MANDATORY SERVICE BULLETIN

NO. MSB-42-062/1

Replacement of the Landing Gear - Down Lock Pin

WI-MSB 42-062

Replacement of the Circlips (Repetitive action every 200 hours)

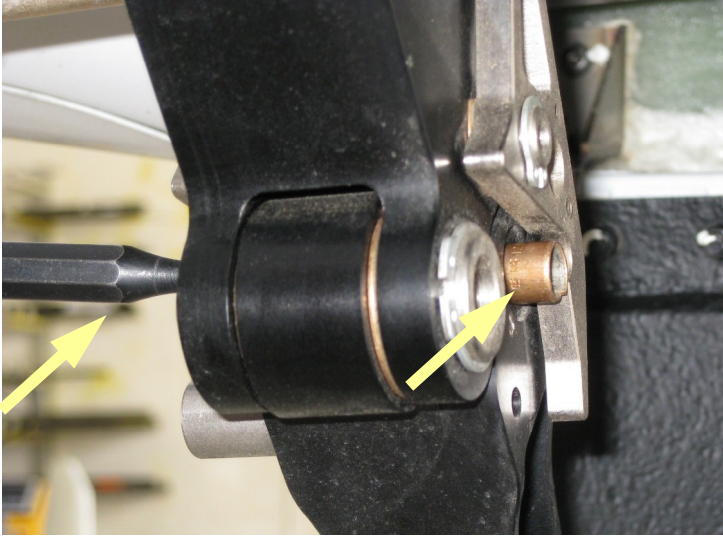
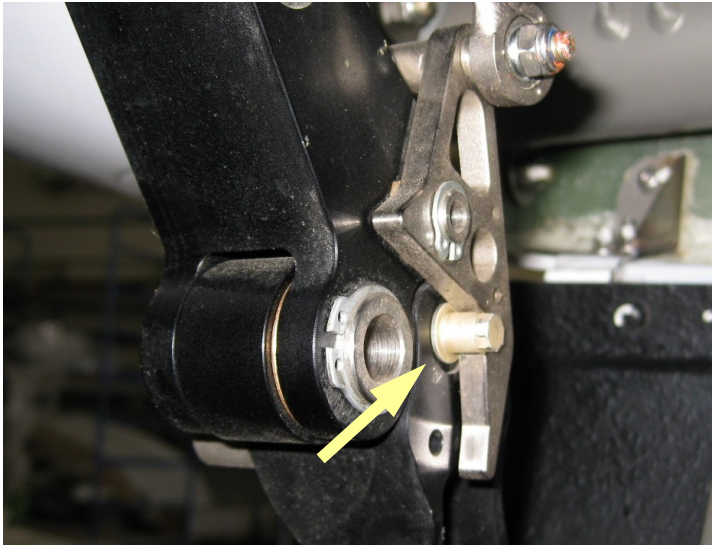
It has been reported, that on a few airplanes circlips of the Landing Gear Down Lock Pins fell off because of corrosion of the clips. To correct this situation, this Bulletin addresses the replacement of the Down Lock Pin circlips of the Landing Gear and subsequently the replacement of these pins with a modified design as the terminating action for repetitive replacement of the circlips.

5	Remove the screw which connects the Hook Rod and the Hook Assembly and turn back the Hook Assembly. Discard the self locking nut.
6	Replace the two circlips which hold the bolt in position. CAUTION: Do not overstress the circlip during the installation!
7	Turn the Hook Assembly into position and reinstall the screw connecting the Hook Assembly with the Hook Rod. Install the new self locking M6 - nut.
8	Clean working area and check for foreign objects.
9	Carry out step 5 – 8 on the Nose Landing Gear and the Main Landing Gear Assemblies.
10	Push the GEAR circuit-breaker and perform a retraction test.

18	<p>Install P/N D60-3237-11-37 and P/N D60-3237-70-00 on the Main Landing Gear Assemblies. (see picture)</p> <p>Prior to installation, apply P/S 870 Class A-2 sealant on Locking Bolts by dipping. Refer also to the sealant manufacturer's instructions. Remove excessive sealant and clean surrounding surfaces.</p> <p>Torque Locking Bolt assemblies with 16+/-2 Nm (11.8 ± 1.5 ft.lbf.).</p> <p>NOTE: New parts are self locking, no additional securing required.</p> 
19	<p>Install P/N D60-3233-00-35 and P/N D60-3233-70-00 on the Nose Landing Gear Assembly.</p> <p>Prior to installation, apply P/S 870 Class A-2 sealant on Locking Bolts by dipping. Refer also to the sealant manufacturer's instructions. Remove excessive sealant and clean surrounding surfaces.</p> <p>Torque Locking Bolt assembly with 16+/-2 Nm (11.8 ± 1.5 ft.lbf.).</p> <p>NOTE: New parts are self locking, no additional securing required.</p>
